GROWTH MANAGEMENT DEPARTMENT STAFF REPORT
SOUTH ANASTASIA OVERLAY DISTRICT

April 28, 2022 Public Meeting
SADRB 2022-01 Matanzas Market

Summary of Request: The applicant requests design approval for the exterior remodel of the existing commercial building located on the site.

Figure 1: Elevation Drawings

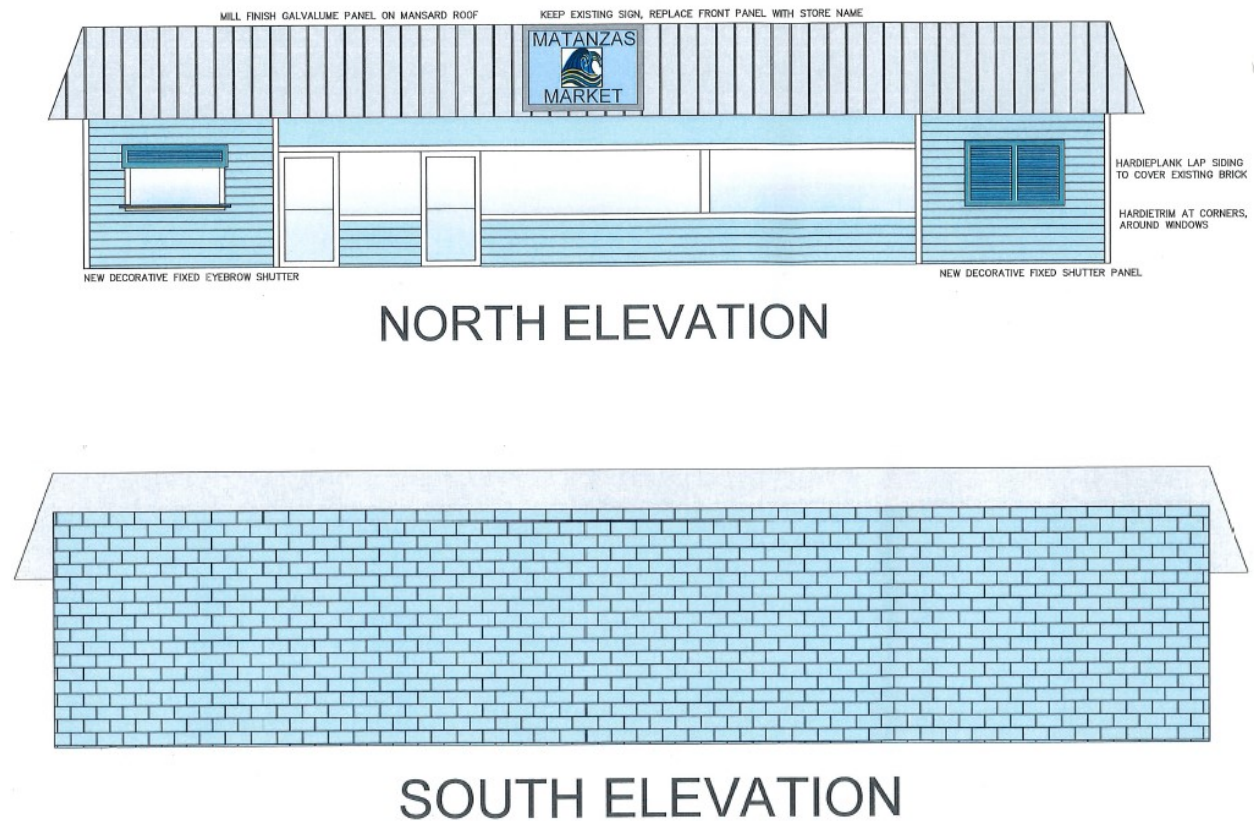
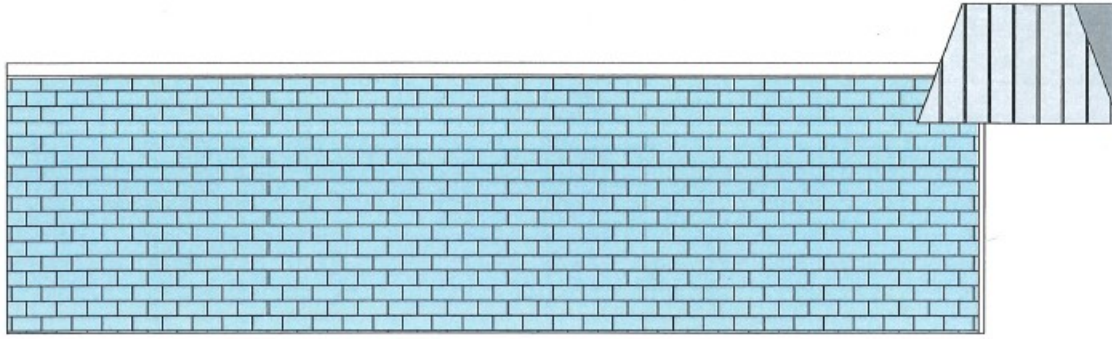
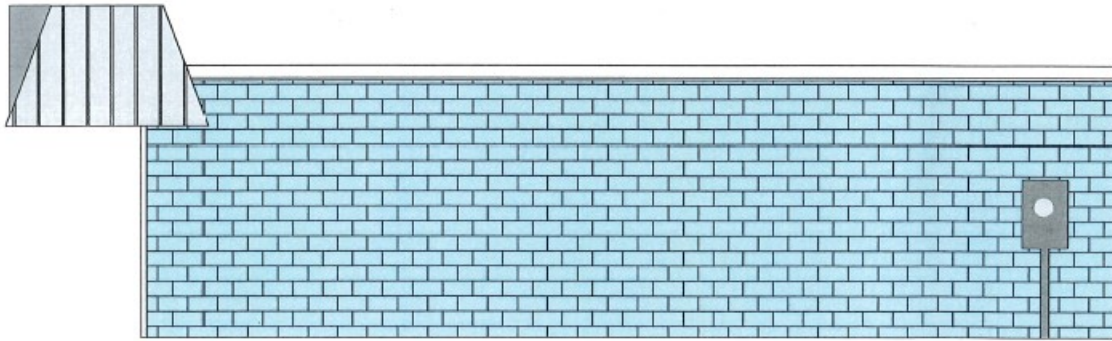
The applicant is requesting design approval to renovate the façade of the entire building. Provided application materials state that the applicant intends on installing HardiPlank Lap Siding over the existing brick veneer of the store front. A new Mill Finish Galvalume roofing is proposed for the faux-Mansard roof on the store front. The remainder of the building will be repainted with the color samples provided below in Figure 3. The HardiPlank Lap Siding and block walls are proposed to be repainted Meander Blue (SW6484), Bermuda Shutters are proposed Reflecting Pool (SW6486), and HardiPlank trim is proposed Extra White (SW7006). The applicant has proffered two color options as demonstrated in the provided application materials, should the proposed building colors not be acceptable.

The architectural style, shutters, siding, materials, and colors presented with the application materials appear to meet the requirements of the South Anastasia overlay. Overall, staff finds that the proposed renovation appears to be consistent with the “Old Florida” style prescribed within LDC, Section 3.07.01
